**ADDENDUM NO. 3**

**PROJECT: 5524**  
**February 5, 2024**

**BAKERSFIELD CITY SCHOOL DISTRICT  
MUNSEY ELEMENTARY SCHOOL  
HVAC REPLACEMENT  
3801 BRAVE AVENUE  
BAKERSFIELD, CA 93309**

**DSA APP# 03-122489**

Sheet No: **A2.20**

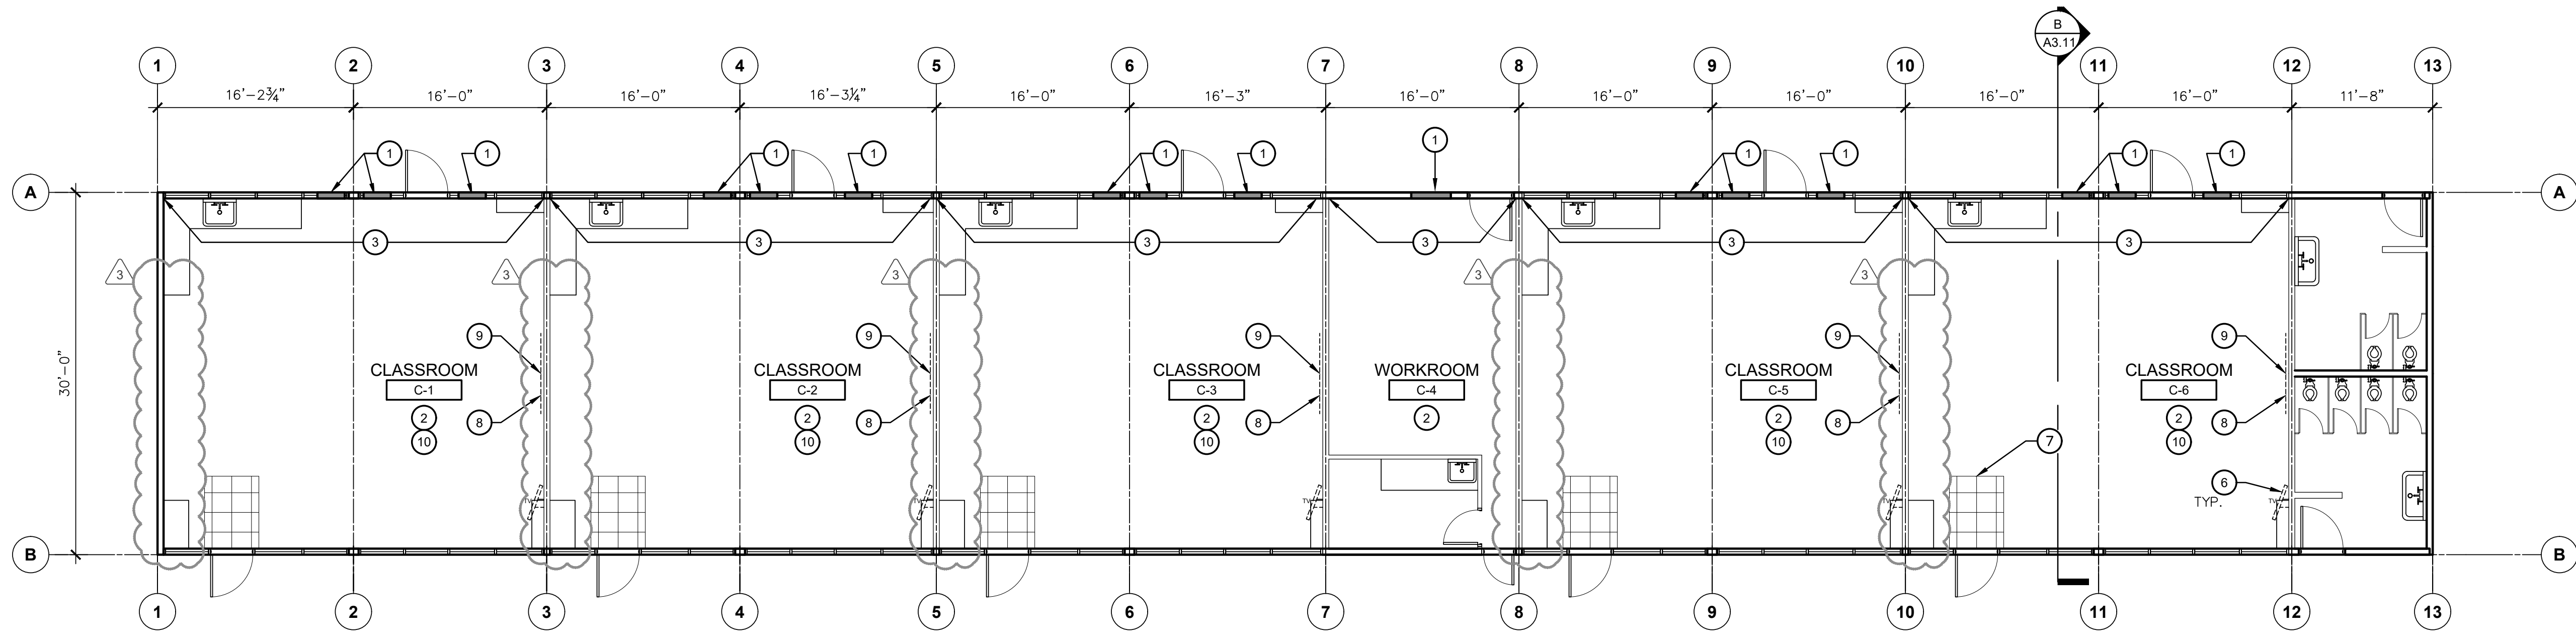
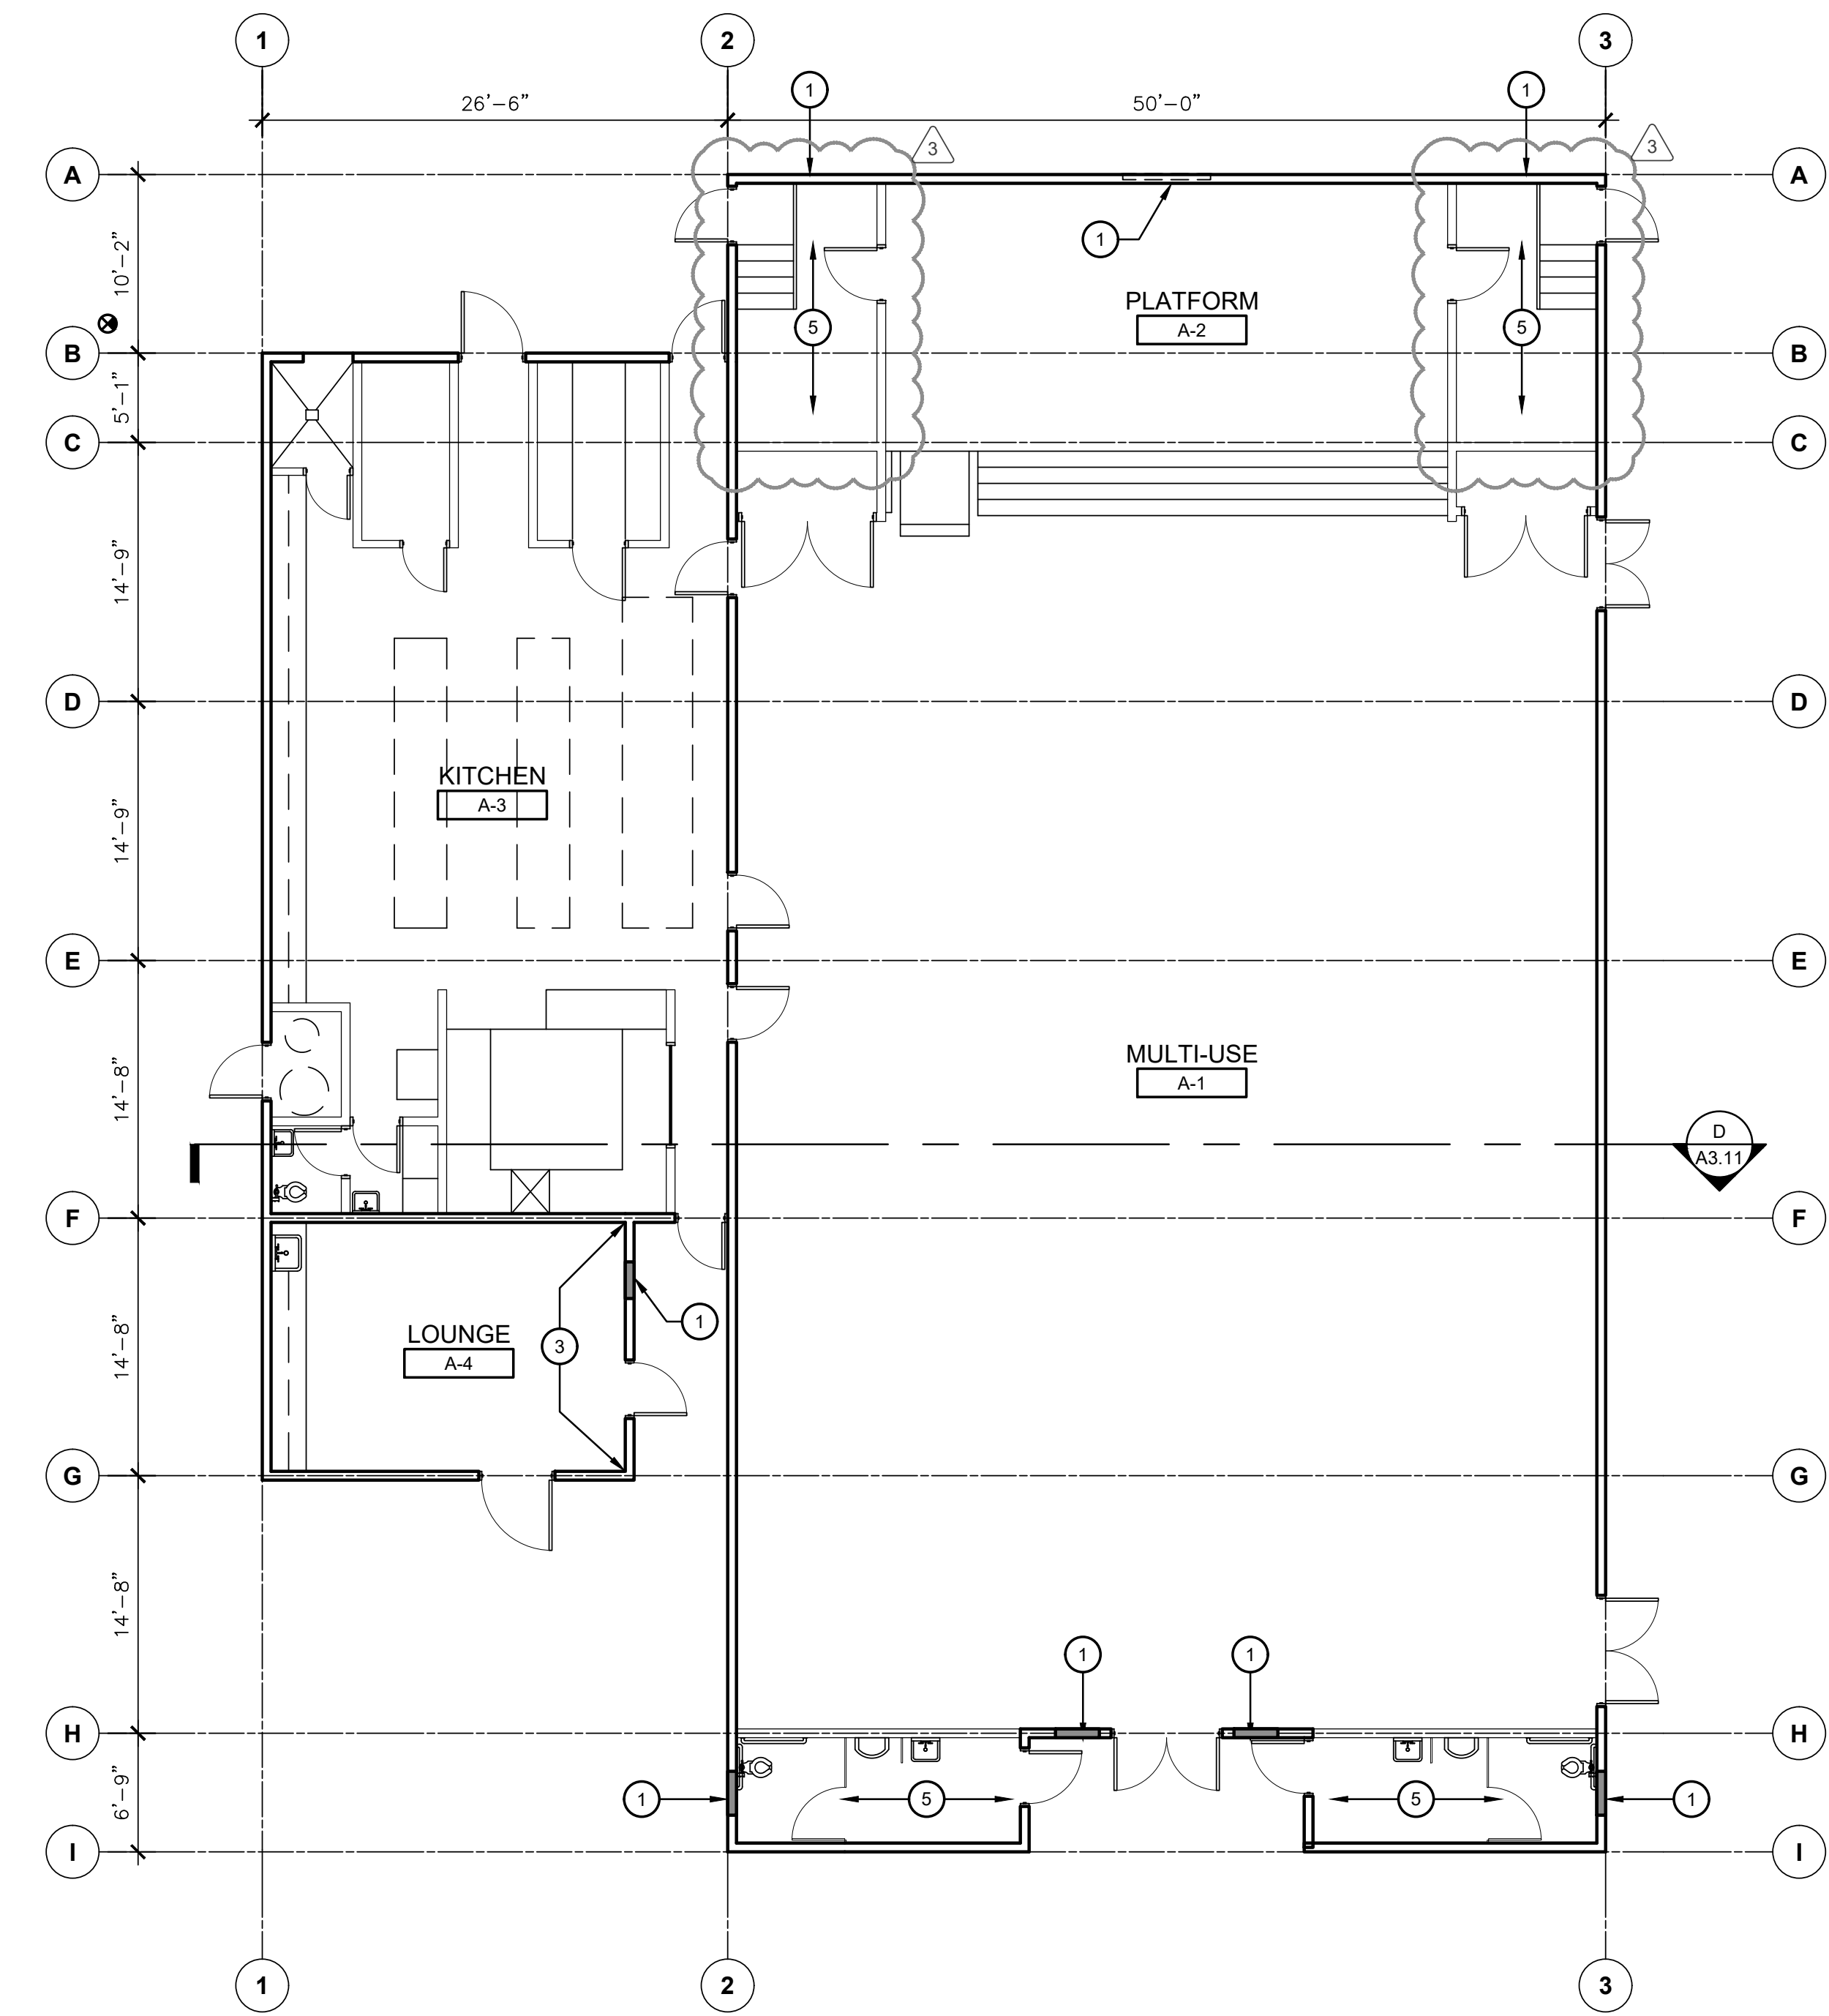
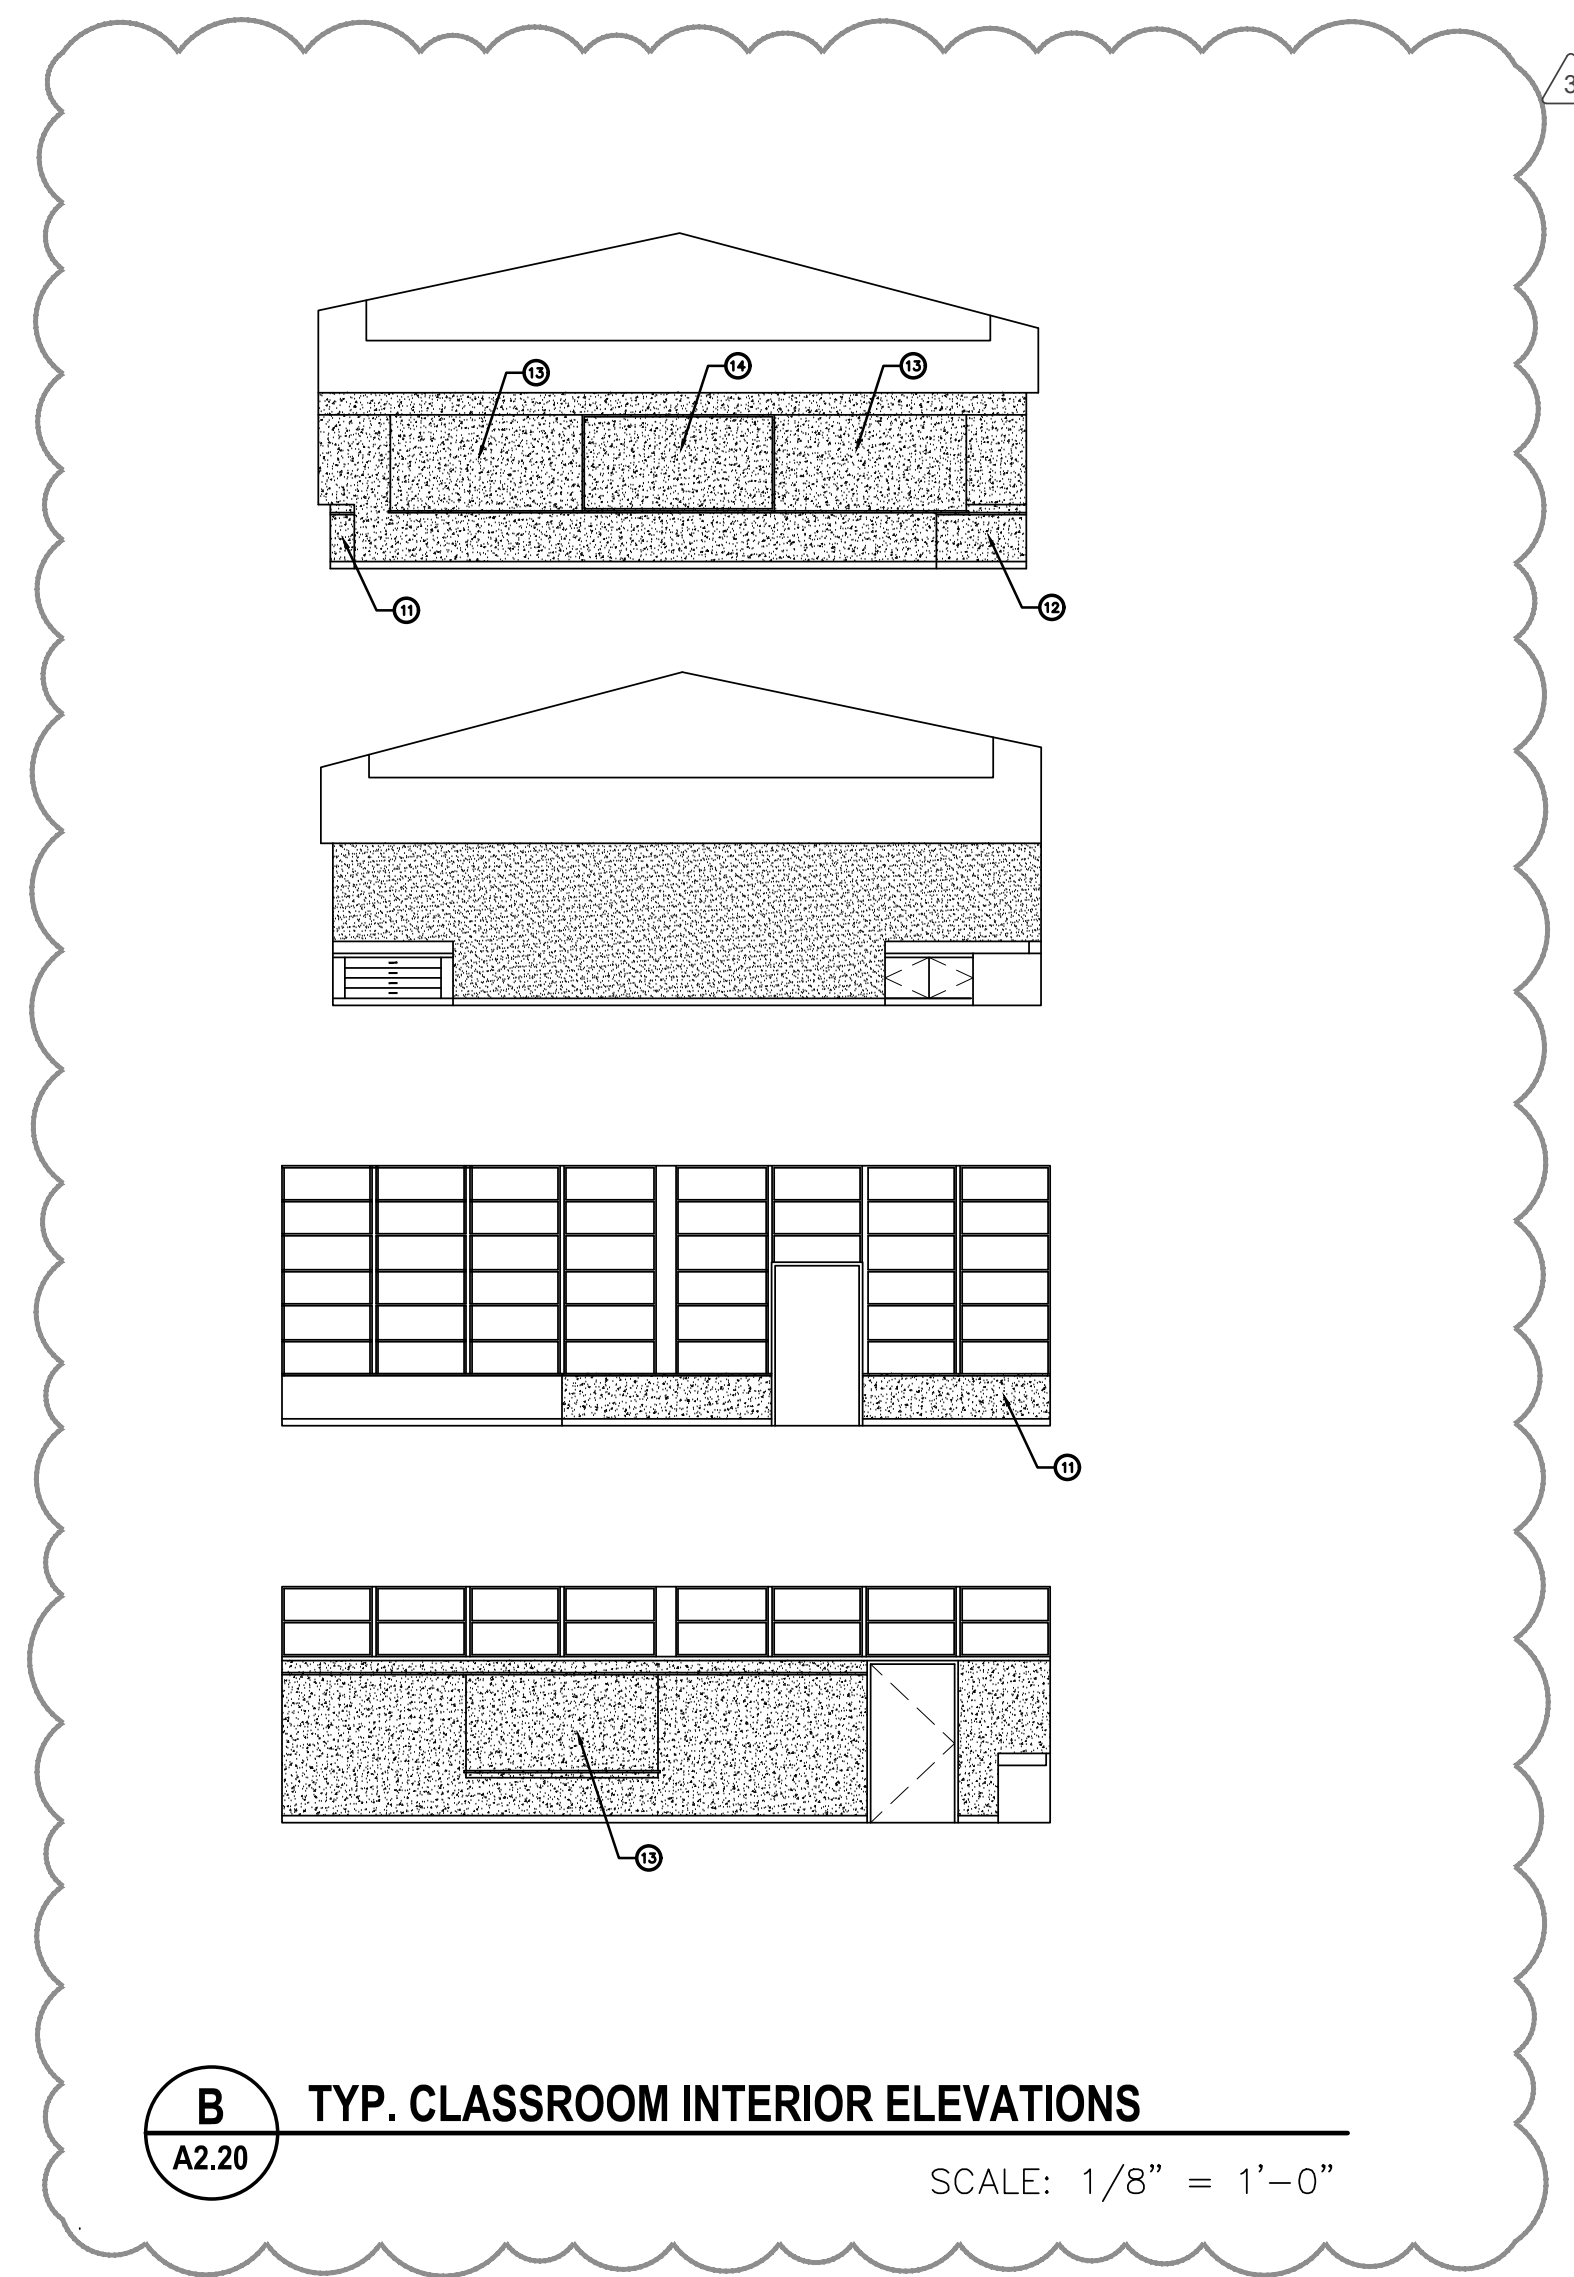
- 3.05 Remove existing radiator as indicated in revised sheets M2.31, M2.41, and M2.51. After the radiator is removed, the area is to be furred out to accept new tackboard finish. District would like to add new tackboard finish to the walls as highlighted on the attached sketch. Chatfield Clark Ceres Fog <https://chatfieldclarke.com/koroseal-ceres/fog-b321-91/>

- 3.07 Sheets A2.10, A2.11, A2.20, and A2.21 have been revised to indicate the removal of a portion of existing cabinets at each of the classrooms.
- 3.08 Remove existing hydronic piping on covered walkway roof between building A and C. The district will assess the condition of the roof after piping is removed to determine if foam roof re-coating will be needed.
